Flood Control District
Of
Maricopa County

VALUE ANALYSIS

SIPHON DRAW DRAINAGE IMPROVEMENTS (CONCEPTUAL PLANS)

February 20, 21, 22, 2008

Recommendation No. 1 and No. 2 (6,3)

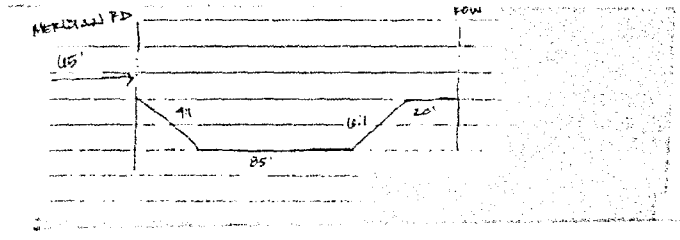
Limit slope to 4:1, no meander

Fits an earthen channel within 160' easement

Limits vegetation to grass and shrubs within flow area

Future road ROW will include landscape buffer & sidewalk

Freeboard is available for tree planting

Need exploration to determine exact x-section needs

Could consider 4:1-2:1 with rip-rap protection

Disadvantages –forces straight channel alignment, more drops, longer bridges, no fissure mitigation, only one O&M road.

Advantages – More natural, easier to construct, least cost,

Earthen channel has greater associated O & M

Likely to cost less – initial cost; Cost of future road crossings needs to be compared, baseline and proposal.

POST WORKSHOP DECISION – DO NOT RECOMMEND.

Title and General Description of VE Recommendation
#3 (7)

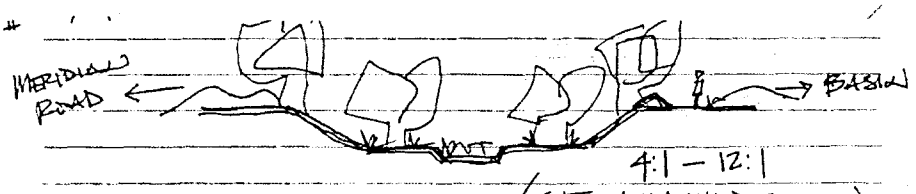
Full aesthetic channel section south of power lines.

Earthen, unlined channel.

Variable side slopes -

6:1 or flatter

Riparian landscape theme in bottom.

Lower Sonoran desert theme side slopes & overbank

4:1-2:1

Lower volume of water for bypass.

Advantages –
Increases scenic & recreation functions; more natural; can landscape within channel; lower initial cost than concrete channel
Disadvantages – Increases O&M cost, may impact diversion options, does not provide fissure mitigation.

POST WORKSHOP DECISION: RECOMMEND.

Title and General Description of VE Recommendation
Recommendation #4 (9 & 56)
Item – split storm drain plus channel on top. Landscaped with grass and trail on top; similar to Old Cross-cut and 10th St. wash.

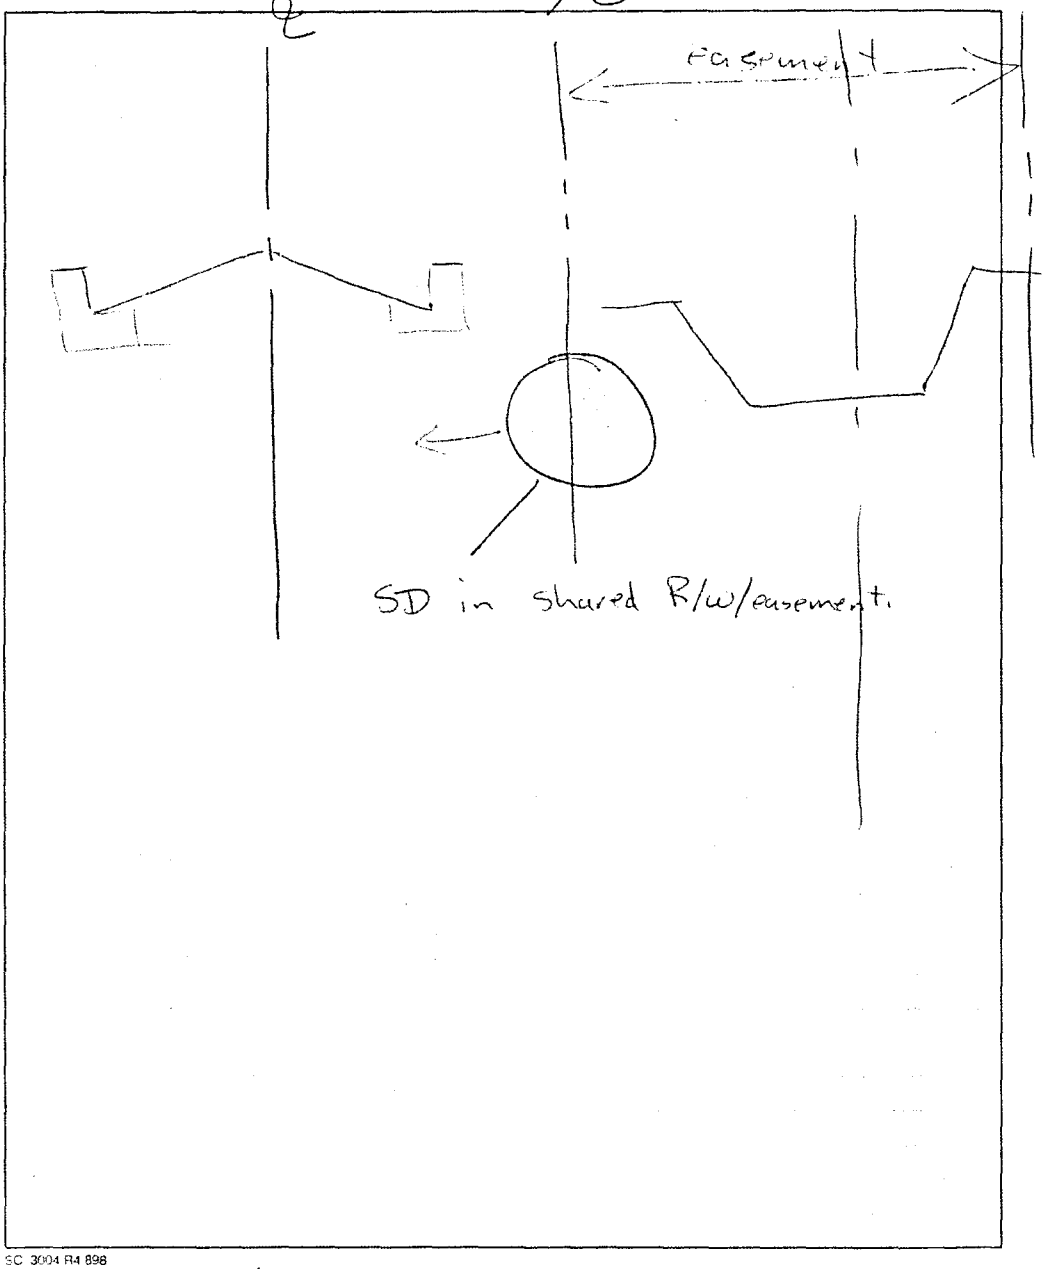
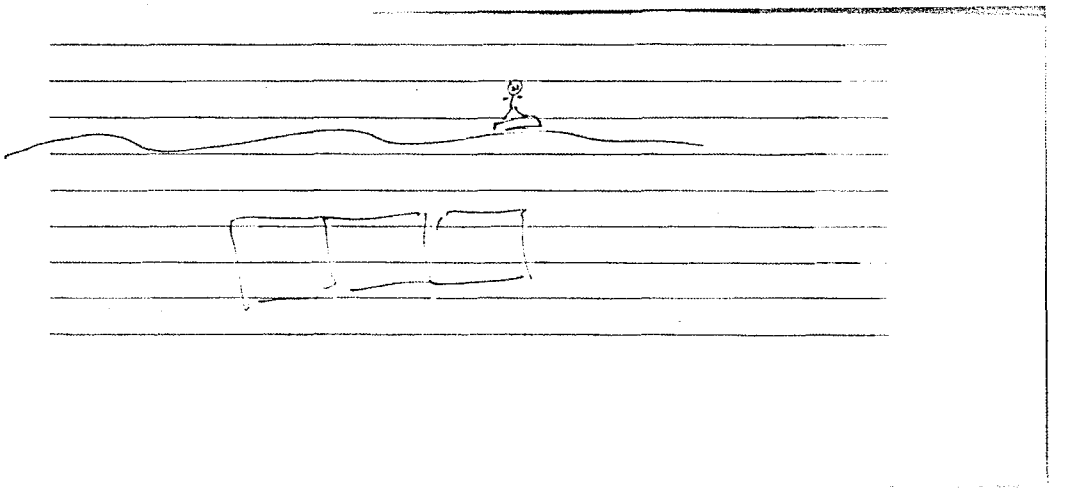
Original design – open channel concrete lined.

The function of the channel is to collect flows and convey them.

The storm drain and channel on top will convey flows. Lower frequency storms will be conveyed in the storm drain, higher frequency will be conveyed in both storm drain and channel on top.

Advantage – provides same function, future roadway improvement can be collected in the storm drain. Provides more room for recreation via trail.
Disadvantage – May not fit within proposed r/w; cost of the project and its implementation, storm drain maintenance, may not have vertical clearance for drop structures; may not have sufficient drop for pipe and channel.

Life-Cycle Cost (Compare to baseline)
Maintenance will be higher compared to baseline, for the trail on top of channel and stormdrain.

POST WORKSHOP DECISION – DO NOT RECOMMEND, TOO EXPENSIVE.

Recommendation #10, #13, #18 (24,28,51,55) COMBINE WITH

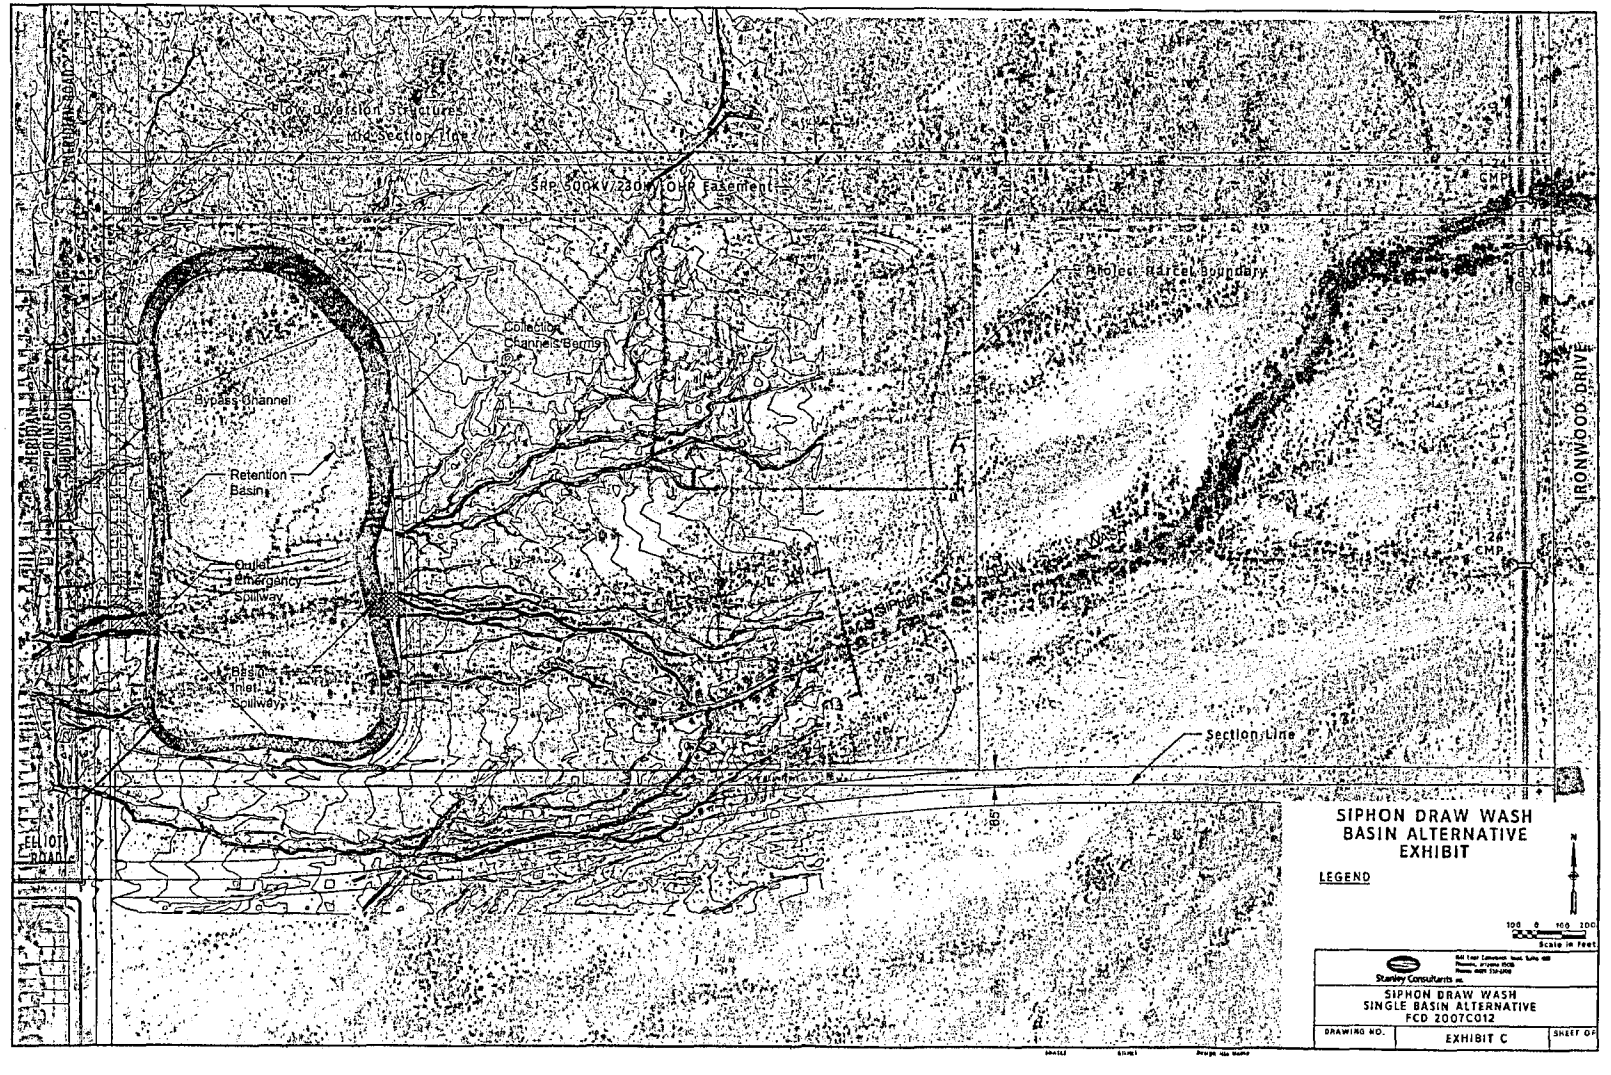
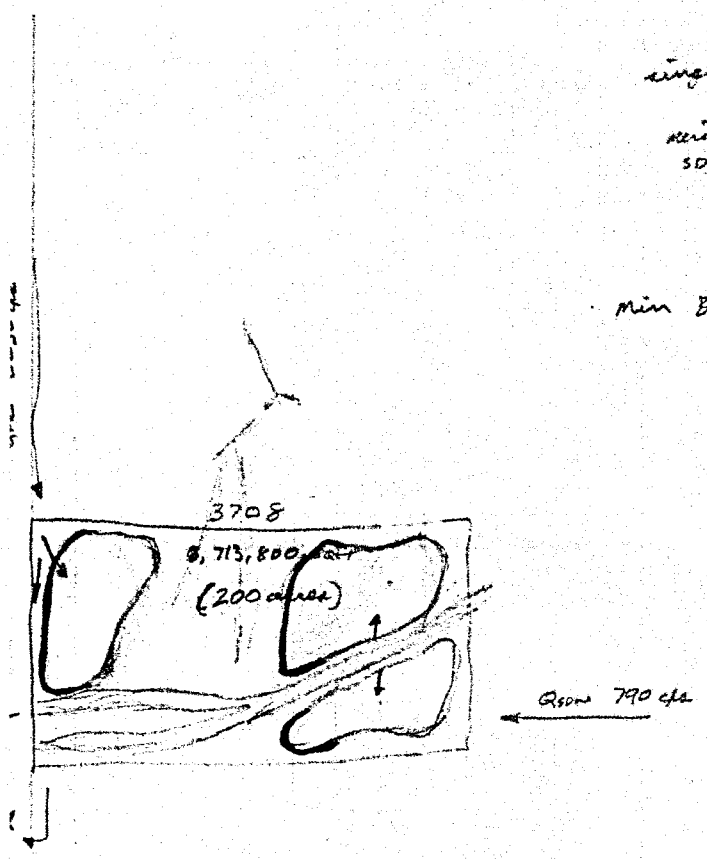
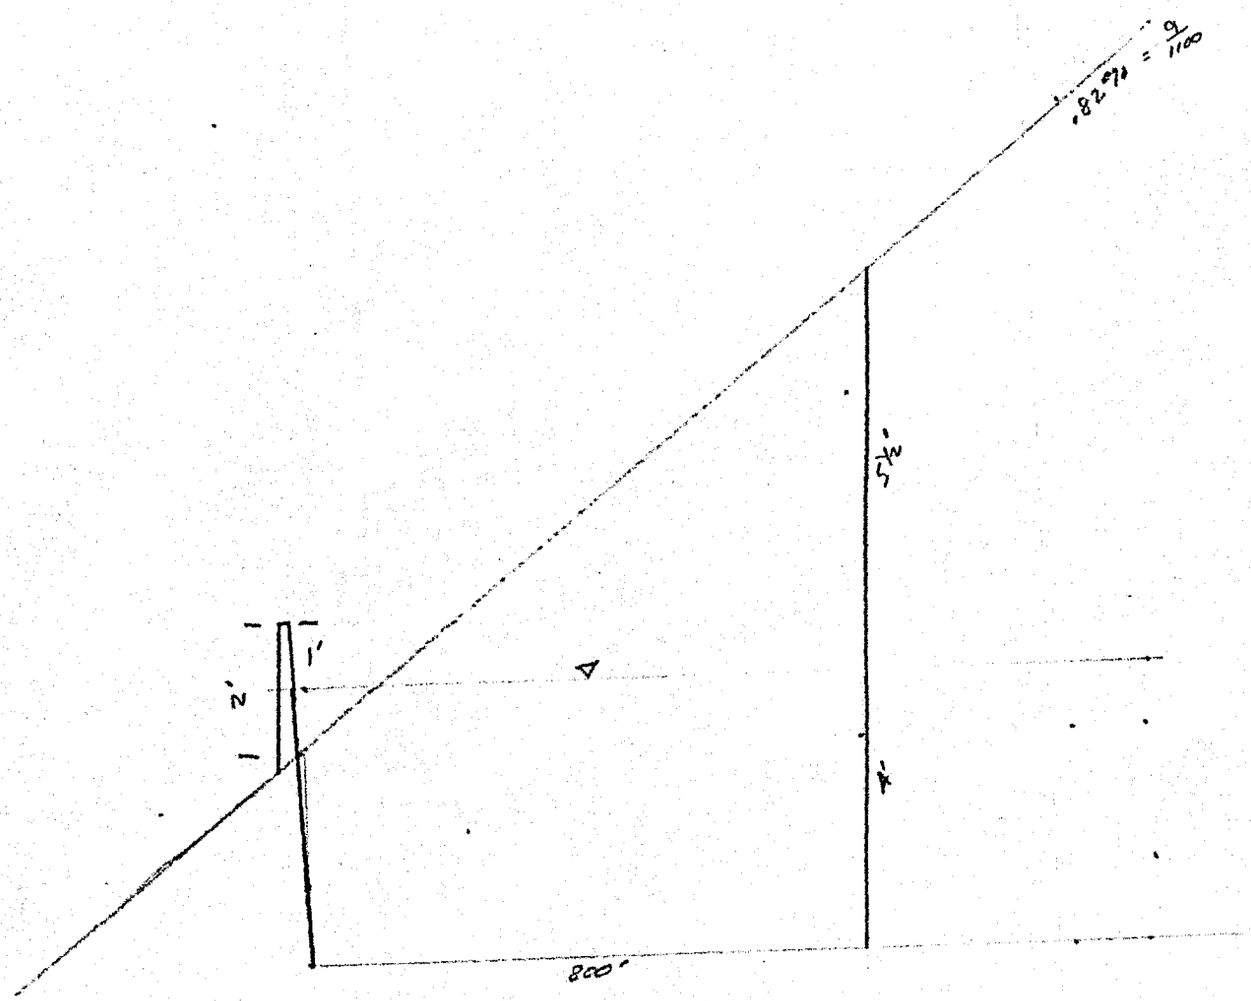
Three shallow basins; offline for Meridian Channel and SDW

Eliminate storm drain – increase basin size -

Drain basins through Siphon Draw

12" +/- retained for infiltration & veg watering

Siphon Draw is outfall

Works; may allow elimination or decrease in length of stormdrain.

Construction cost higher if stormdrain is not eliminated or reduced; $1 million less if storm drain is eliminated or greatly reduced.

Advantages: More opportunity for aesthetics, open space, future recreation; earthwork volumes similar, not just big hole, more contoured to landscape, increases natural rainfall available and lowflows to sustain vegetation growth; preserves natural wash; less sediment into basin(s); less storm drain to construct and maintain; provides for commercial corner for ASLD.

Disadvantages: More basin area to maintain; would need to add hard channelization at wash adjacent to basin weir (200' +/-); more basins means more inlet weirs and outlets; may need to investigate more "lineaments"; may require more fissure mitigation.

POST WORKSHOP RECOMMENDATION: Stanley Consultants Inc. should investigate this further via Optional Item, and compare with Baseline.

D.S. #2 (4, 10, 13, 11)

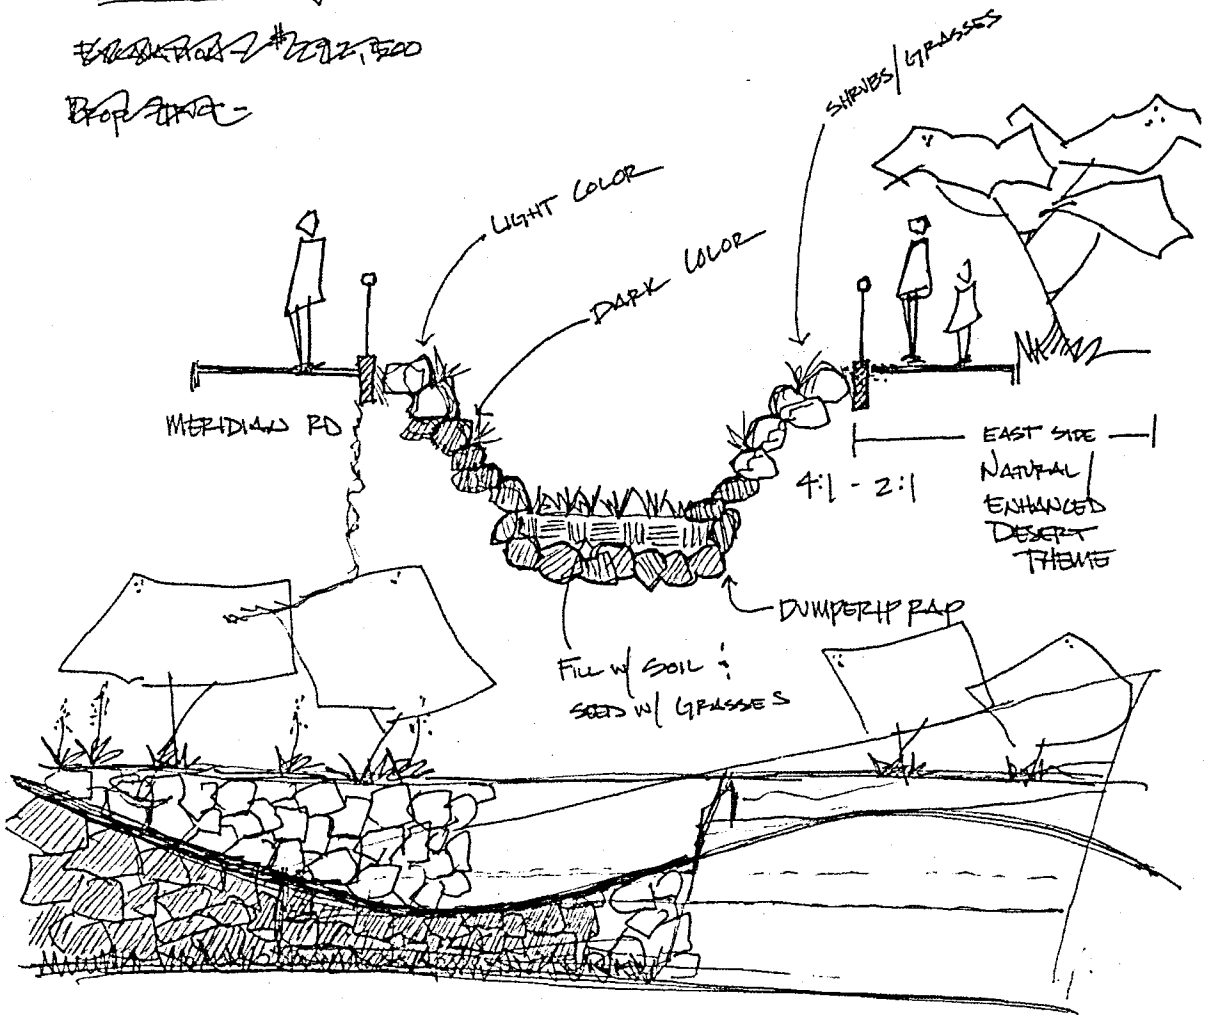
#2 (Channel) Use riprap and/or soil cement for erosion/slope protection in an aesthetic manner such that it is a feature attraction.
